ADDENDUM #1 for DD COST PACKAGE

November 13, 2020

DD Cost Package- Supplementary Notes REVISED

Additions or Changes to SD Scope (Added notes in Blue)

STRUCTURAL

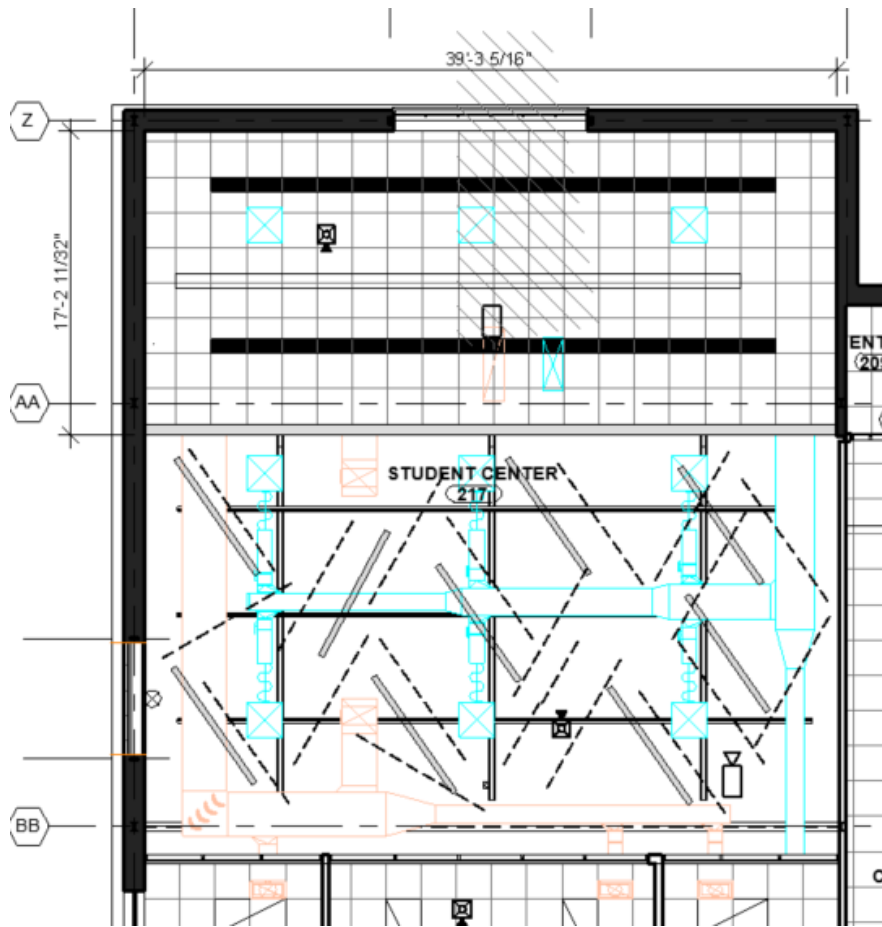
- Provide additional roof support for new mechanical equipment on roof such as the new RTU and DOAS units; Provide any structural support needed for mechanical equipment above corridor 200

Student Lounge Ceiling & Lighting

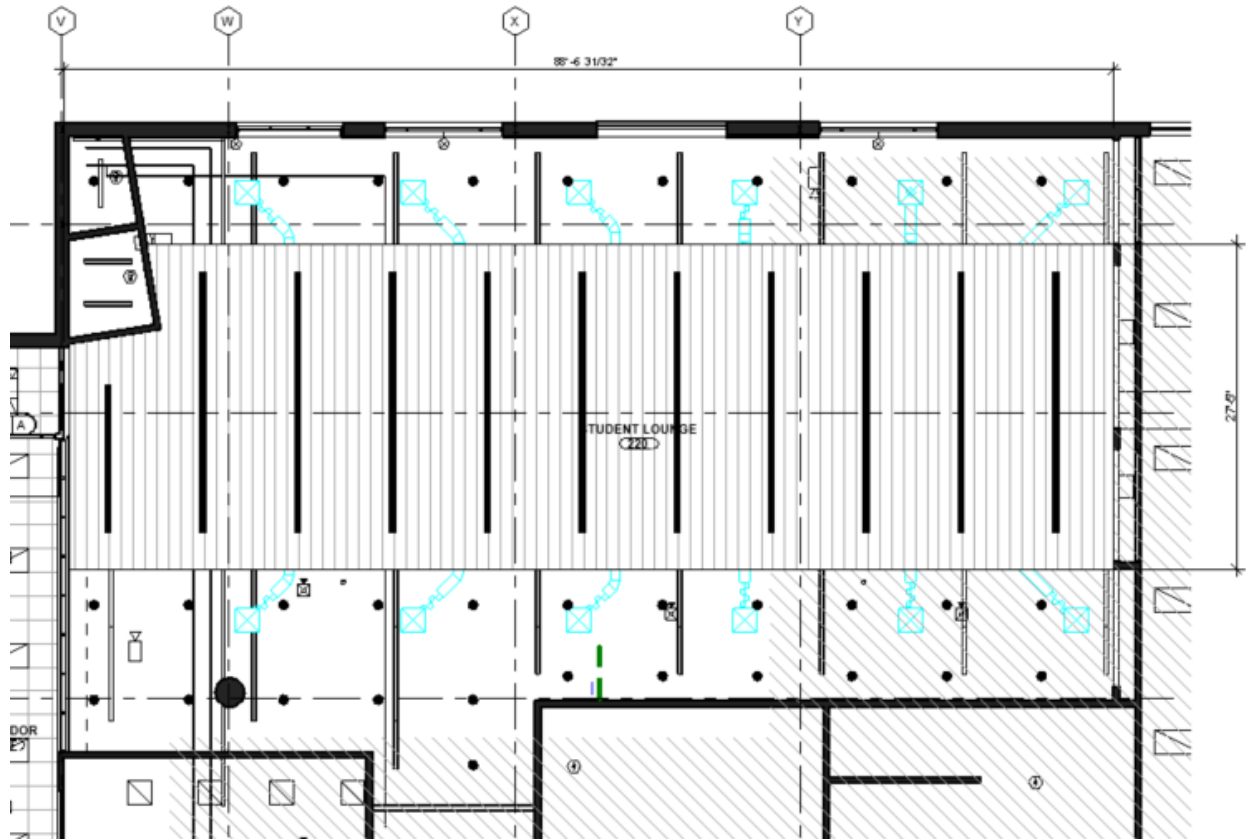
- Painted exposed ceiling and ductwork with acoustical ceiling (Armstrong, Lyra Plant Based, 4"x60" tiles, tegular, custom color tile and grid) with 6" Axiom classic edge (custom color) -89'x30' ceiling
- 4" x 22' recessed linear LED fixtures= 11 total

- LED cylinder pendant lights = 33 total

CEILING

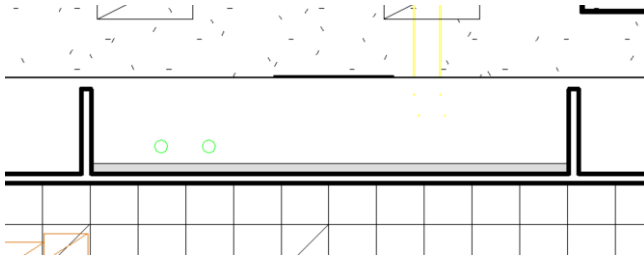
- At Simulation labs (Rm B.1.114 & B1.116), Game Rooms (Rm B1.103, 105, & 107), and Server Hub (Rm B1.110)
 - Provide black ACT ceiling and grid
 - Basis of Design for lighting – Arlee Lighting, T-Grid Frames
- Include recessed, continuous, LED linear light fixture at booth ceiling where wall and ceiling meet – basis of design Arlee Lighting, T-Grid Linear fixture. Full length of each booth like below:

RETRACTABLE WALLS

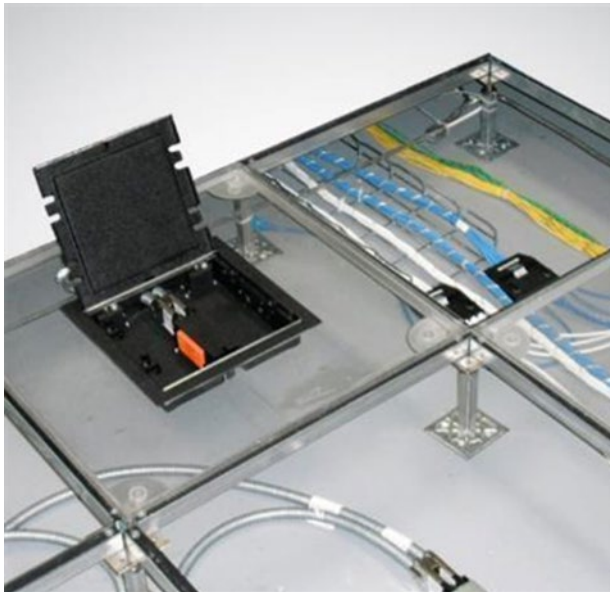
Include retractable wall with gyp bd soffit in lieu of metal stud wall between medium classrooms (B1.103, B1.105 & B1.107) across from large classroom and networking labs in Building B.

BOD-Modernfold Operable Partition Continuous Hinge Automated Wall System. Floor to ceiling height. Included with retractable walls, classroom doors to be fire-rated wood doors and sidelites to include rated glazing. Stud wall assemblies for these classrooms at the corridor to be 1-hour rated assembly, including floor slabs.

INTERIOR SIGNAGE

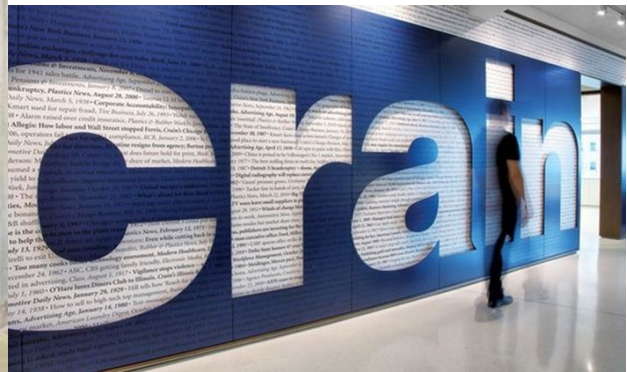
- A. Frosted acrylic panel with background image, raised letters and braille and Small acrylic room number sign
 1. Located at every room. (Offices to include the small number sign only).
 2. Larger version of frosted acrylic panel for directory located at elevators
- B. Custom Graphic film (refer to finish plans for location)
 1. Large numbers at stairs
 2. Large quote and image graphics at lounges, library
 3. Logo wall – raised logo with graphic film at Main Entry of Building 100
 4. Custom film at storefront windows at Tutor rooms and Conference Room at Building B
- C. Plastic Laminate Panels with cutout letters at back of reception desk and ceiling to match color on second floor of Building B – **16' wide x ceiling height**

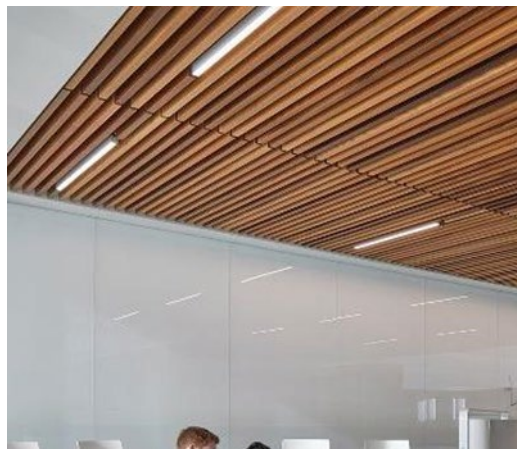
- Provide allowance for wood ceiling like below in library popup at Building 100 and main entry ceiling at Building B.
 - Basis of Design: [Armstrong, ACGI Grill Panels](#)

6. **Corridor 200 – Building 100**

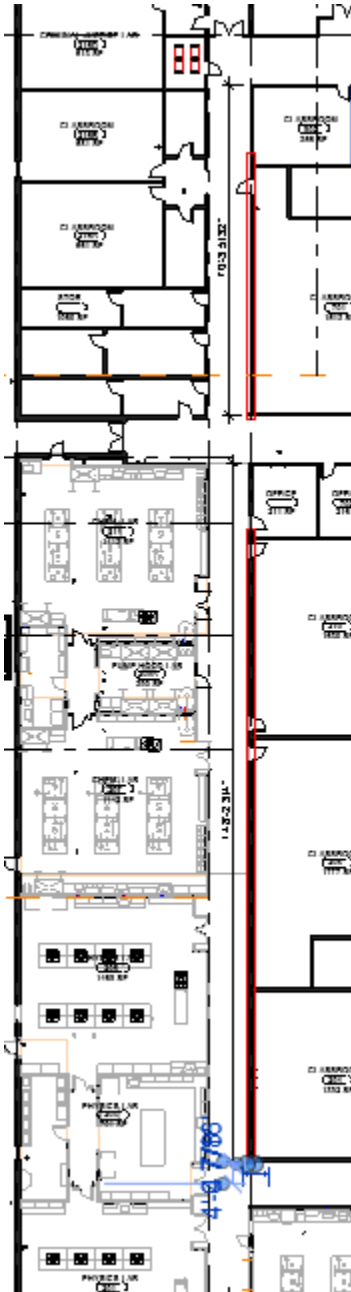
Include in Scope: Make walls on East side of corridor 200 1-hour rated construction, including bringing walls up to under deck, installing fire-rated doors, sealing all penetrations. Approx. 218' of wall. (Underside of deck is 13' above floor; height of existing wall 10'8" +/-). See red highlighted walls below.
